2022 GROUP B PUBLIC COMMENT AGENDA

SEPTEMBER 14 - 21, 2022
KENTUCKY INTERNATIONAL CONVENTION CENTER
LOUISVILLE, KY

2022 Public Comment Agenda

FIGURE R704.2.1(1) TYPICAL SINGLE-SPAN VINYL SOFFIT PANEL SUPPORT

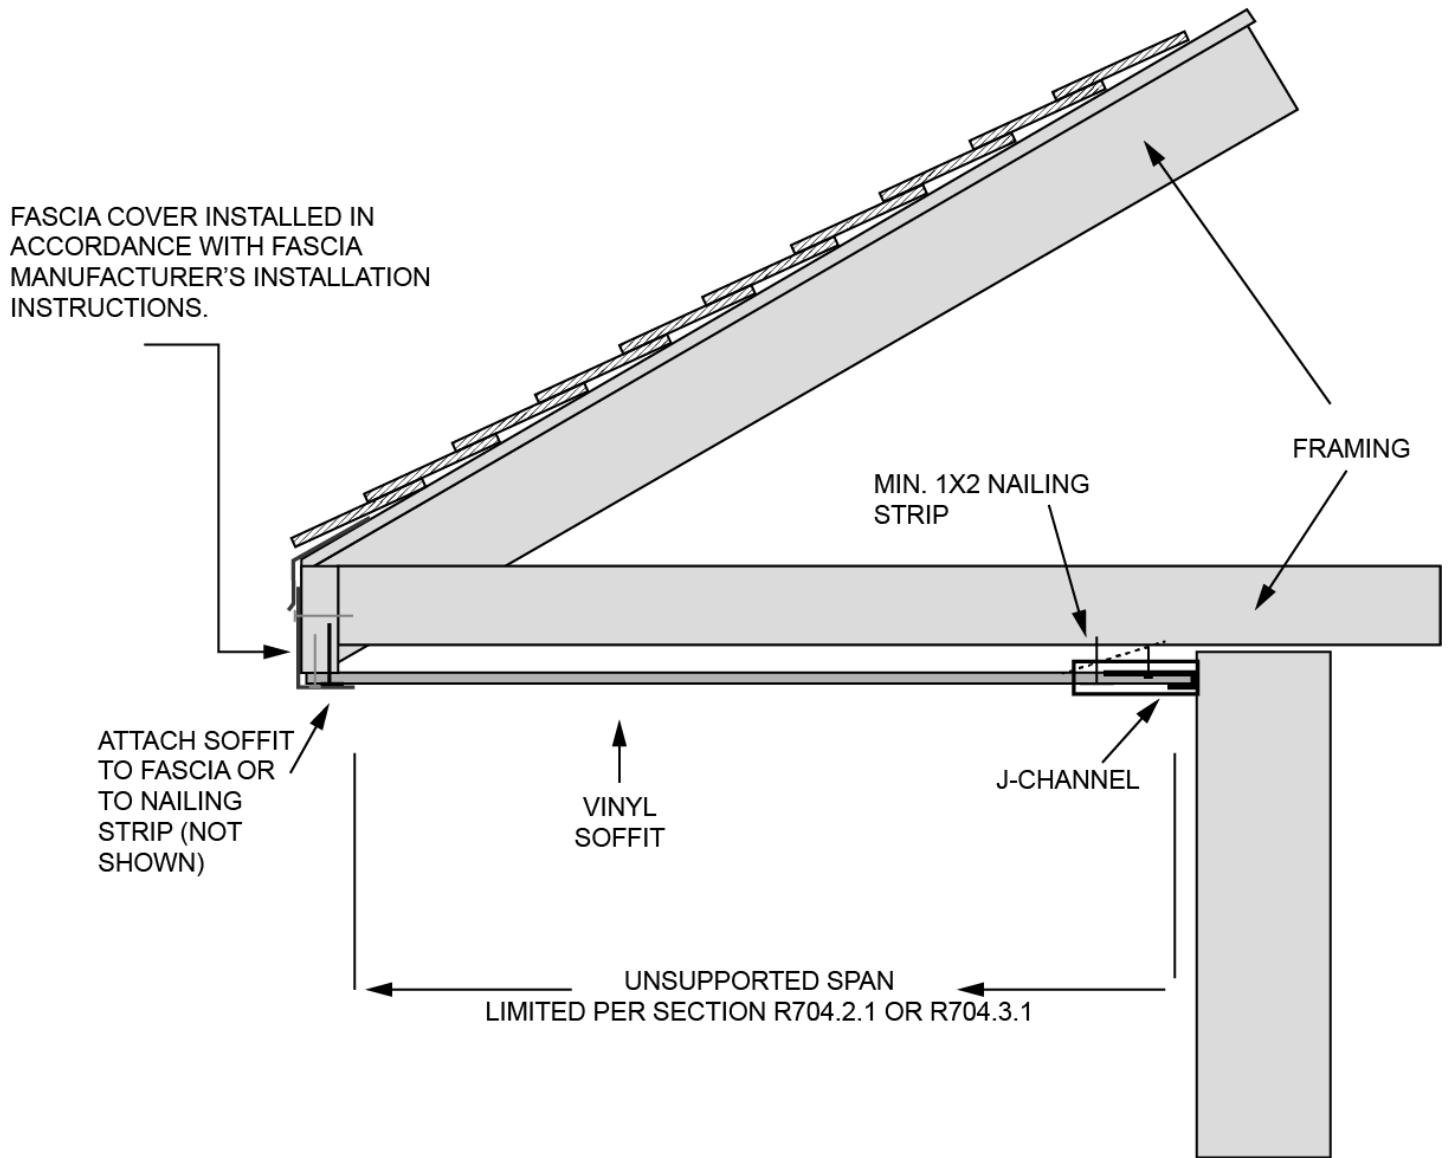
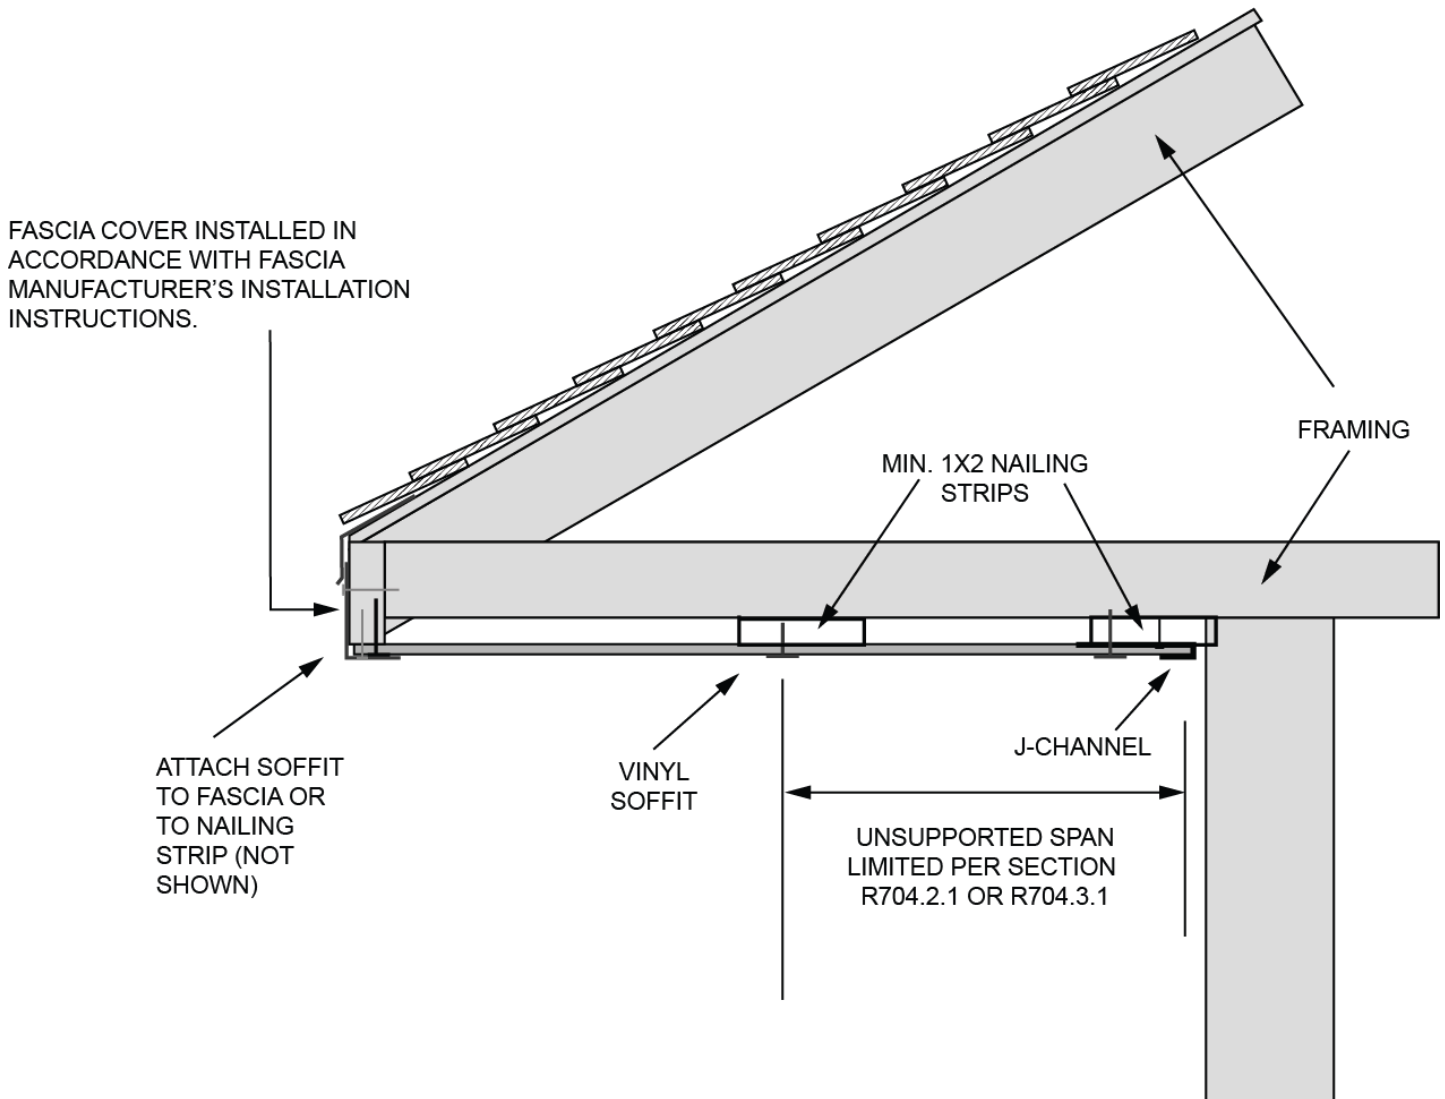
(Add 'exterior' in front of 'soffit' in three locations.)

FIGURE AF101.1 EPA MAP OF RADON ZONES

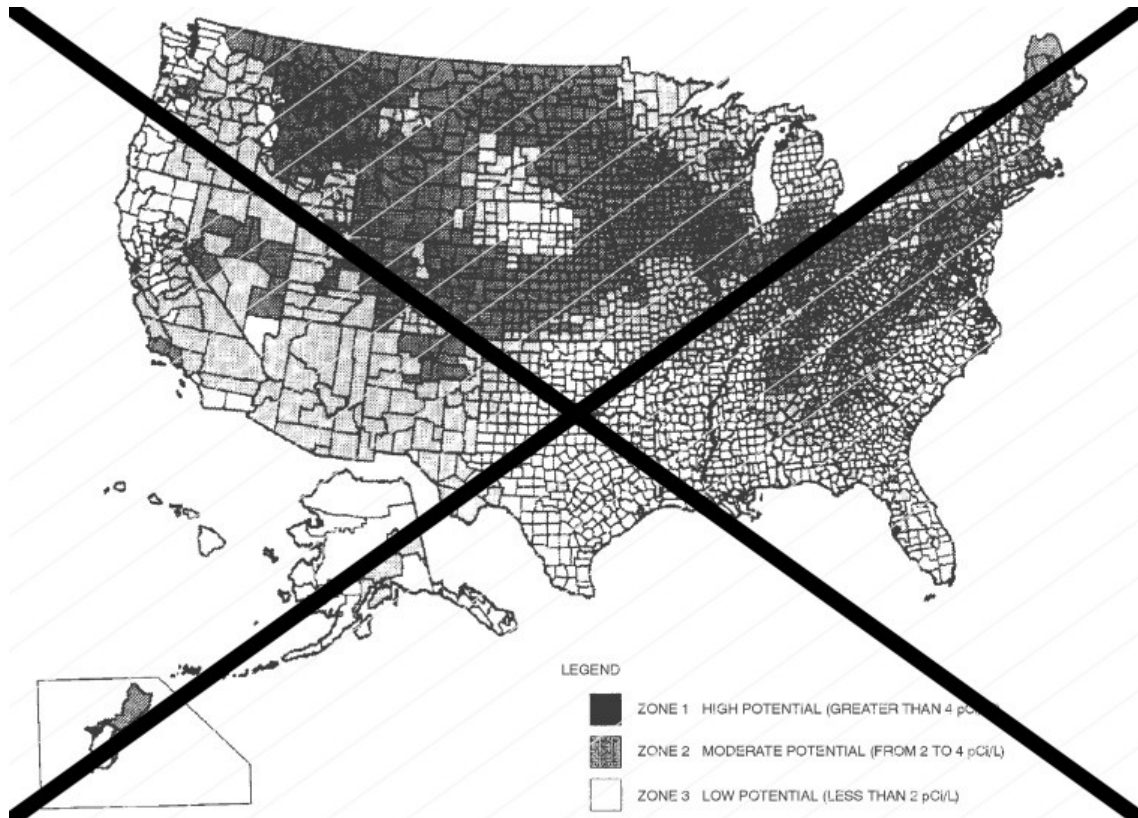
Delete without substitution:
